Subject: 210 PCH, Hearing Tues

Honorable Commissioners:

RE: Traffic and Parking Study Comments CUP for 210 Pacific Coast Highway
April 18, 2024

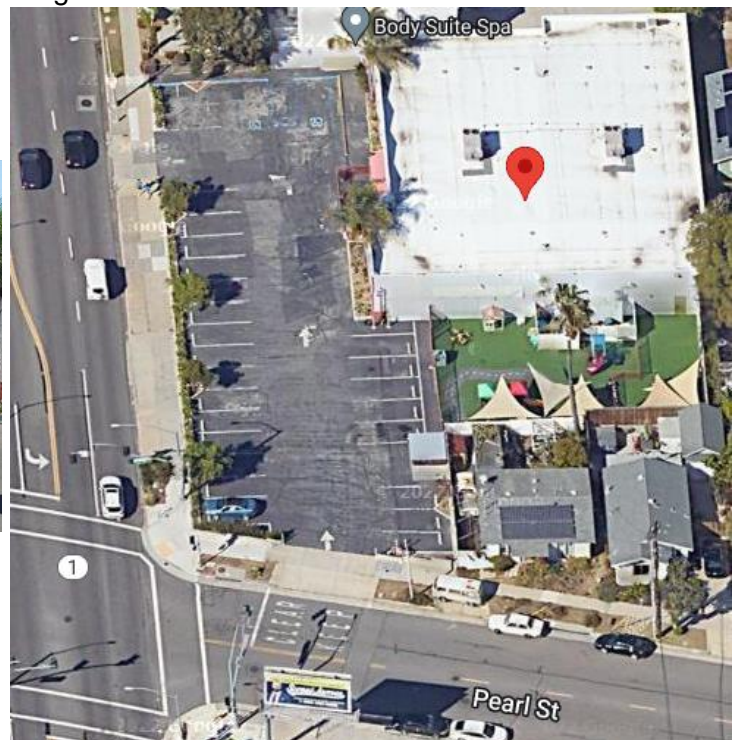
The initial part of 2nd is two-way street where it meets PCH, and then becomes a one-way street, but there isn't room for two-way traffic when cars are parked at the mouth of 2nd street where it joins PCH.

As you can see in this photo looking west on 2nd, where there is a silver car parked on the left preventing the white Audi from entering, when the cars are waiting for the red light to turn green.

They didn't think this through as there will **still be back-ups on PCH** for those **traveling north on PCH turning right onto 2nd** and can't enter due to **parked cars not allowing enough room on 2nd to enter** (See picture on pg 2), except when the light changes, but there will be so much queuing on 2nd, that will be very difficult.

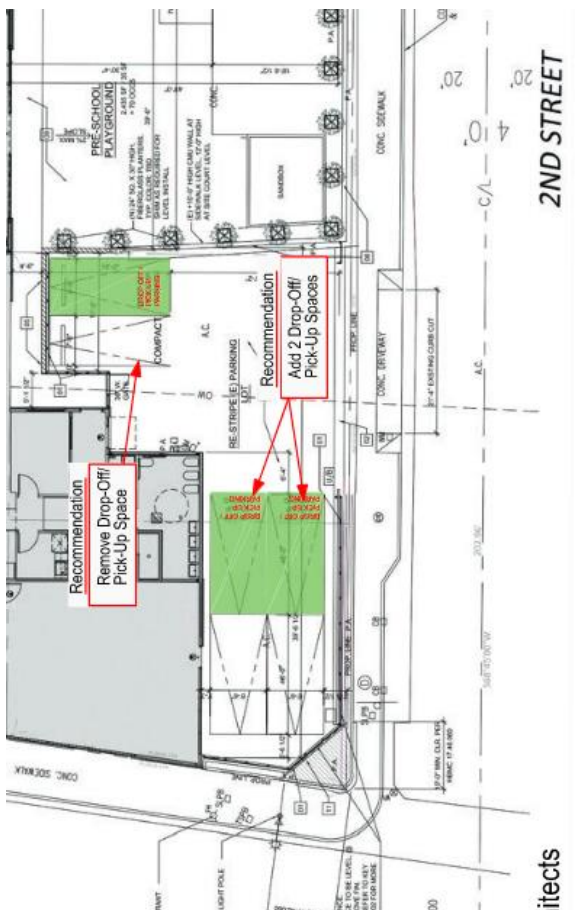
With Children's Journey Day Care on PCH, they followed the law and have the proper amount of **loading/unloading** with a total of **22 parking spots** for a max of **66 kids** (per Winnie.com). This equates to up to **9 spots for employees plus 13 more spots for loading/unloading**, with one entrance from a large two-way street (Pearl), and arrows directing for one exit onto PCH:

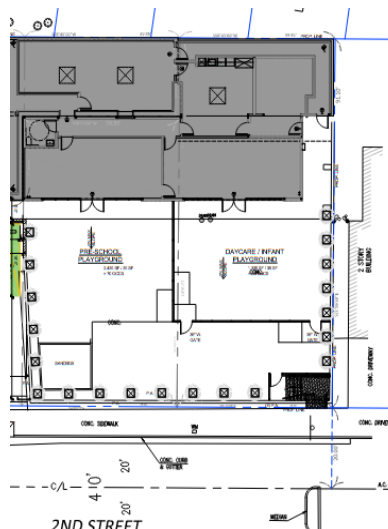
In the first draft of CUP/Parking Plan Analysis & Findings, the applicant is wants to increase the day care to **98 kids** (and with the current plan would allow for 144 kids), but since the first draft, they deleted the end of the 2nd sentence re: 98 kids, and even left it blank on your current copy (without moving up the next sentence):

What control measure will be put in place to prevent more than 77 kids at the daycare. This also needs to be part of the CUP. They only want to get the interior square footage from the back of the building to grow the facility larger, violating the CUP for 77 kids.

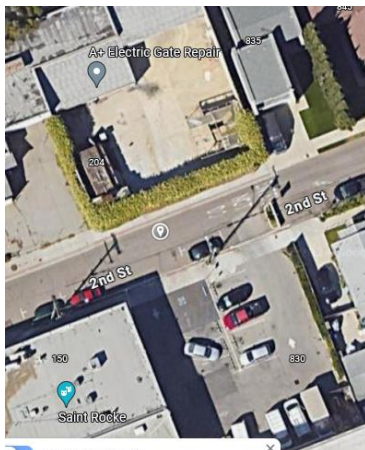
A more appropriate plan would be to have all **5 spots for drop offs on PCH**, along **with 2-spots on 2nd**. The two front tandem spots would be for staff (minus 2 at the entrance to back parking lot to enter garages), along with **retaining the garages for staff for 12 spots.**

Keeping the back garages allows for 12 spots (8 as tandem) for staff that is sorely needed to free up spots in the front of the lot for unloading and loading! This would still give the applicant more interior sq ft than is needed (4,094 sq ft). You’ll note that the plans show that only the front of the building is needed for 80 kids.

The 7 loading spots in the front will still not be enough on at peak times, so the Okell’s lot should also be used for the extra 7 loading spots that will be needed.
